Access Compliance Report

Public Rights-of-Way

Intersection ID: 12265	Main Street: S_CHURCH_ST	Cross Street: W_4TH_ST	Location: W
ADA ID: 3298C14CC05B	Ramp Type: PerpDiag	Initial Pass/Fail: Fail	Overall Compliance: No
Codes/Mitigation Info/Possible Solution		Field Measurements/Component Compliance	
Severity Score: 10

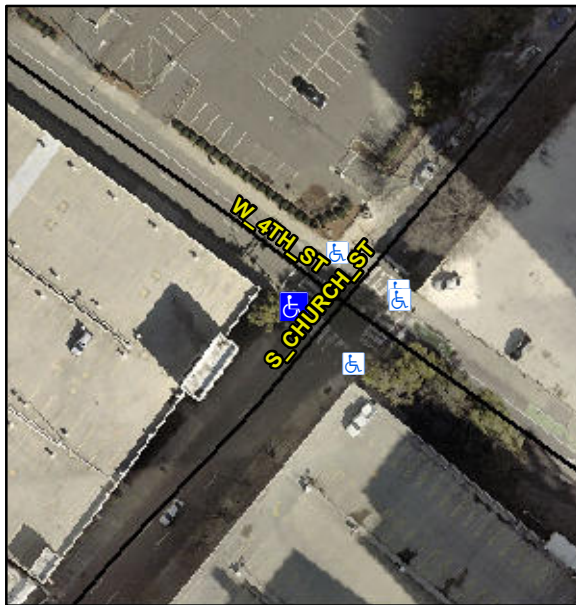
Not Found, R304.5.1, R304.5.3

Compliance	Description	Data	Compliance	Description	Data
N/A	Ramp Length (in)	51.0	Yes	Ramp Slope (%)	7.0
No	Ramp Width (in)	40.0	No	Ramp XSlope (%)	2.4
N/A	Flare Type LT	N/A	N/A	Flare Type RT	N/A
N/A	Flare Slope LT (%)	N/A	N/A	Flare Slope RT (%)	N/A
N/A	Flare Traversable LT?	N/A	N/A	Flare Traversable RT?	N/A
N/A	Landing Length (in)	N/A	N/A	DWS Provided?	N/A
N/A	Landing Width (in)	N/A	N/A	DWS Contrast?	N/A
N/A	Landing Slope (%)	N/A	N/A	DWS Length (in)	N/A
N/A	Landing X Slope (%)	N/A	N/A	DWS Full Width?	N/A
N/A	Landing Curb? (Y/N)	N/A	N/A	DWS Offset (in)	N/A
N/A	Shared Landing?	N/A			
N/A	Gutter Ponding?	N/A	N/A	Gutter Slope (%)	N/A
N/A	Gutter Lip Ht (in)	N/A	N/A	Gutter X Slope (%)	N/A
N/A	Painted X Walk1?	Yes	N/A	Painted X Walk2?	Yes
	X Walk 1 Direction	To SE		X Walk 2 Direction	To NE
N/A	X Walk 1 Width (in)	112.0	N/A	X Walk 2 Width (in)	107.0
	X Walk 1 Slope (%)	2.8		X Walk 2 Slope (%)	2.2
	X Walk 1 X Slope (%)	2.2		X Walk 2 X Slope (%)	1.9

Remove & Replace Curb Ramp With Two New Directional Ramps or Equivalent.
